Technical Note

Project name Glen Earrach	Subject Additional Information to Chapter 3: Evolution of Design and Alternatives	Date April 14 2026
Prepared by AC Senior Civil Engineer	Checked by MC Project Manager	Verified by DL Technical Director
		Approved by MC Project Manager

Figure 1 Extract of Chapter 3 Section 3.4.9

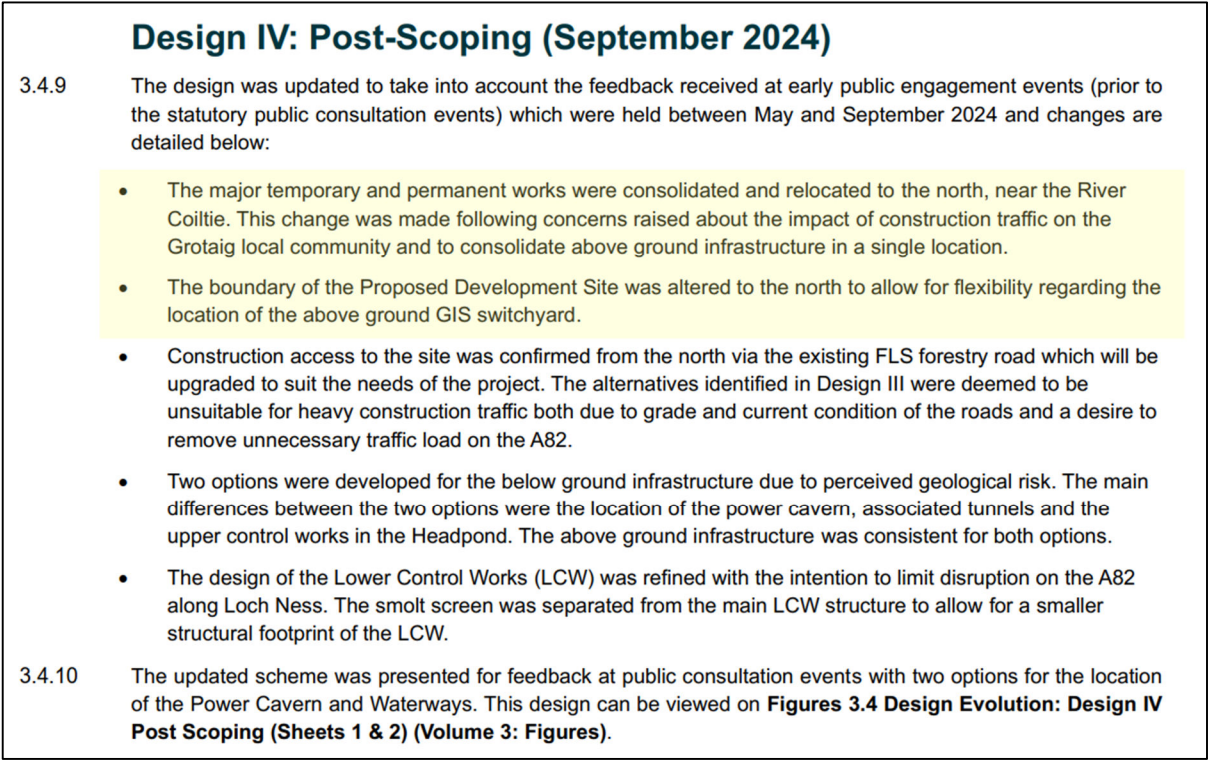
3.4.9A In addition to the factors described in **paragraph 3.4.9**, the consolidation and relocation of the major temporary and permanent works to the north of the Proposed Development Site at Design IV (Post-Scoping, September 2024) was also informed by consideration of the future grid connection. At the time of the Design IV revisions, the Applicant held a grid connection offer citing the future Bingally Substation as the connection point¹ but without any available transmission line routing information. The relocation of the above-ground infrastructure, including the GIS switchyard, to the northern part of the Proposed Development Site was undertaken in part to provide a logical and efficient connection corridor towards Bingally, with the objective of achieving a transmission line routing that would avoid likely significant adverse environmental effects.
